Kewaunee Nuclear Power Plant
Operated by Nuclear Management Company, LLC

Responses To NRC Clarification Questions On Responses To Requests For Additional Information Regarding License Amendment Request 195, Stretch Power Uprate For Kewaunee Nuclear Power Plant (TAC NO. MB9031)

Responses to NRC Clarification Questions on Responses to Requests for Additional Information Regarding LAR 195

Figure 1

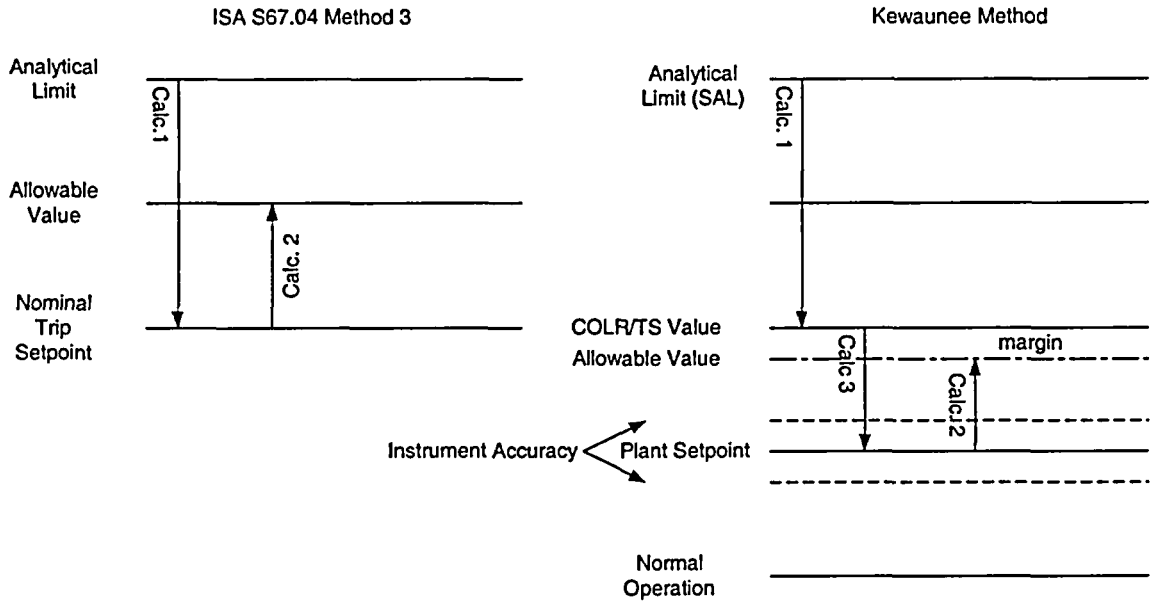
1. NMC's December 15, 2003 response to NRC item 9 described the setpoint methodology used for the KNPP. The NRC staff requires additional information associated with how channel operability is determined.

Using the above information for the OPDT instrument the determination of the setpoint and operability value can be further explained. The SAL is 1.16. This means that the operators would see a value of 116% on their OPDT setpoint indication if this were the OPDT setpoint. To determine the OPDT setpoint the CSA and margin are subtracted from the SAL (1.16 - 0.063 - 0.0015 = 1.0955 [or ≅ 1.095]). This is the value that is entered into the KNPP COLR for the OPDT setpoint (K_4). To determine the plant trip setpoint additional margin is subtracted from the COLR value. This value (margin) is a historical number that has been demonstrated by experience to ensure the COLR value will not be exceeded (0.0125). Adding this margin yields a plant trip setpoint of 1.0825 or 108.25% full power ΔT, as indicated in the control room.

NUREG 1431, Standard Technical Specifications Westinghouse Plants," revision 2 states that there is some point beyond which the device would have not been able to perform its function due, for example, to greater than expected drift. This value needs to be specified in the technical specifications in order to define OPERABILITY of the devices and is designated as the Allowable Value. NMC determines an allowable value but not by the same method used in ISA 67.04 and does not currently utilize this "Allowable Value" for the determination of operability for the KNPP. NMC uses the plant setpoint ± instrument accuracy value for the determination of operability.

For operability and calibration tolerance of the OPDT trip function at KNPP NMC uses the COLR/TS value and the instrument accuracy, respectively (see Figure 1). For example, an instrument and control (I&C) technician is performing a calibration of an OPDT channel. The I&C technician finds the K_4 setpoint to be 1.085. The I&C technician will leave the setpojnt as found because it is within 0.5% span (0.5% span is instrument accuracy or 0.5% x 150 = 0.0075) of plant setpoint of 1.0825. Thus if the I&C technician finds the setpoint to be within 1.0825 ± 0.0075 the setpoint is not adjusted, it is left as is. If the as found setpoint is outside the ±0.5% instrument accuracy the setpoint is adjusted to be within that instrument accuracy band and the channel determined to be inoperable until adjusted within the accuracy band. If an as found setpoint is outside of the instrument accuracy band NMC also performs an evaluation of the condition. If the setpoint is found to be within the KNPP allowable band the instrument is determined to meet its design function.

Calculation 1 (Calc.1) adds/subtracts the measured uncertainties and unmeasured uncertainties plus margin from the analytical limit.
Calculation 2 (Calc.2) adds/subtracts the measured uncertainties.
Calculation 3 (Calc.3) adds/subtracts the measured uncertainties plus a margin (margin may be as low as zero)

Although NMC uses the instrument accuracy in determining operability of the instrument, the plan is to expand the operability band to the KNPP allowable value. Thus the instrument would be considered operable until the setpoint exceeded the KNPP allowable value. Additionally there are some instruments at KNPP that the value for Calc. 3 and/or Calc. 2 has not been determined. For these instruments NMC uses the TS/COLR value, adds/subtracts a historical value that has been shown to prevent exceeding the TS/COLR value and bases operability on the instrument accuracy band.

Thus further margin is added between the analytical limit and the actual plant setpoint.
